Access Compliance Report

Public Rights-of-Way

Intersection ID: 27495	Main Street: BALLANTYNE COMMONS PY	Cross Street: NORTH COMMUNITY HOUSE RD	Location: SW
ADA ID: 7F7D462D54CE	Ramp Type: Perp	Initial Pass/Fail: Pass	Overall Compliance: No
Severity Score: 0.25			
Codes/Mitigation Info/Possible Solution		Field Measurements/Component Compliance

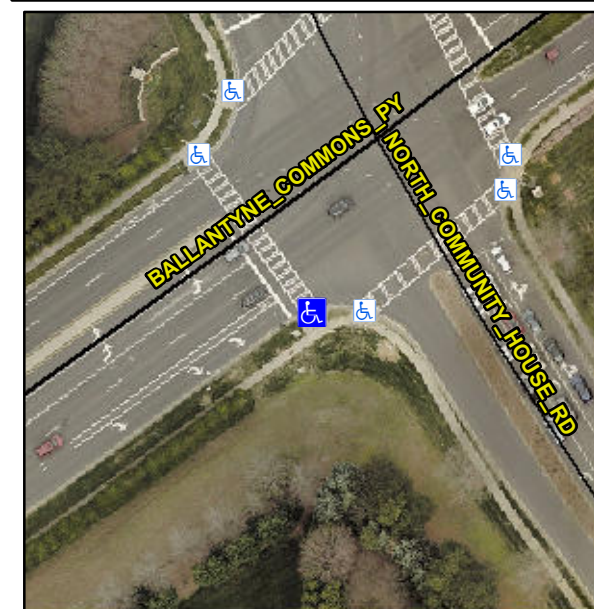
**Not Found, R304.5.3, R304.2.1,
R304.2.2-Perp, R304.3.2-Para**

Compliance	Description	Data	Compliance	Description	Data
N/A	Ramp Length (in)	25.0	Yes	Ramp Slope (%)	5.3
Yes	Ramp Width (in)	48.0	No	Ramp XSlope (%)	2.5
N/A	Flare Type LT	Sloped	N/A	Flare Type RT	N/A
N/A	Flare Slope LT (%)	3.0	Yes	Flare Slope RT (%)	10.0
N/A	Flare Traversable LT?	Yes	N/A	Flare Traversable RT?	Yes
Yes	Landing Length (in)	77.0	Yes	DWS Provided?	Yes
No	Landing Width (in)	47.0	Yes	DWS Contrast?	Yes
No	Landing Slope (%)	3.0	Yes	DWS Length (in)	24.0
No	Landing X Slope (%)	3.5	Yes	DWS Full Width?	Yes
N/A	Landing Curb? (Y/N)	No	Yes	DWS Offset (in)	1.0
N/A	Shared Landing?	No			
Yes	Gutter Ponding?	No	Yes	Gutter Slope (%)	4.8
Yes	Gutter Lip Ht (in)	0.0	No	Gutter X Slope (%)	4.8
N/A	Painted X Walk1?	Yes	N/A	Painted X Walk2?	N/A
	X Walk 1 Direction	To NW		X Walk 2 Direction	N/A
N/A	X Walk 1 Width (in)	124.0	N/A	X Walk 2 Width (in)	N/A
	X Walk 1 Slope (%)	4.4		X Walk 2 Slope (%)	N/A
	X Walk 1 X Slope (%)	2.3		X Walk 2 X Slope (%)	N/A

Possible Solutions:

**Remove & Replace Entire Ramp.
Remove & Replace Gutter.**
